Project	IEEE 802.16 Broadband Wireless Access Working Group <http://ieee802.org/16>
Title	Proposed text and ASN.1 code to support new parameters in Table 342
Date Submitted	2007-03-09
Source(s)	Joey Chou Intel Corporation [mailto:joey.chou@intel.com]

Abstract	This contribution proposes the text and ASN.1 code in wmanIf2mMib to support new parameters in Table 342.
Purpose	Adoption
Notice	This document has been prepared to assist IEEE 802.16. It is offered as a basis for discussion and is not binding on the contributing individual(s) or organization(s). The material in this document is subject to change in form and content after further study. The contributor(s) reserve(s) the right to add, amend or withdraw material contained herein.
Release	The contributor grants a free, irrevocable license to the IEEE to incorporate material contained in this contribution, and any modifications thereof, in the creation of an IEEE Standards publication; to copyright in the IEEE's name any IEEE Standards publication even though it may include portions of this contribution; and at the IEEE's sole discretion to permit others to reproduce in whole or in part the resulting IEEE Standards publication. T

Figure 16—wmanIf2mBsCm structure

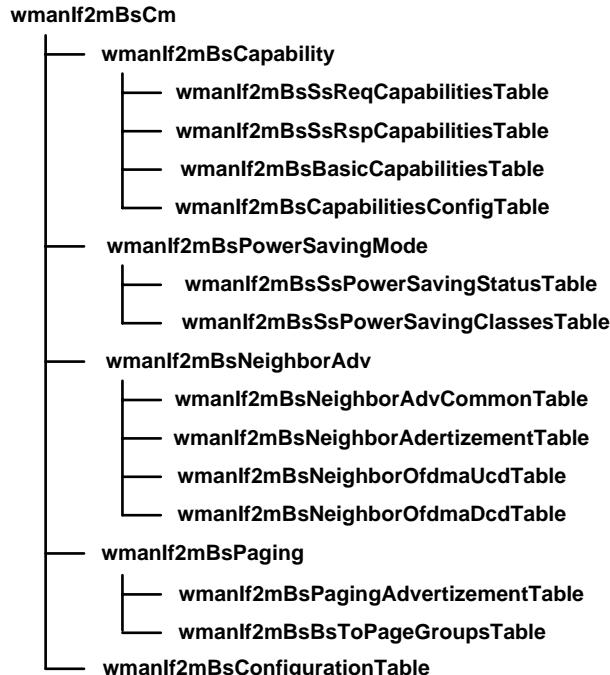
9 [Change Figure 16 as the following:]
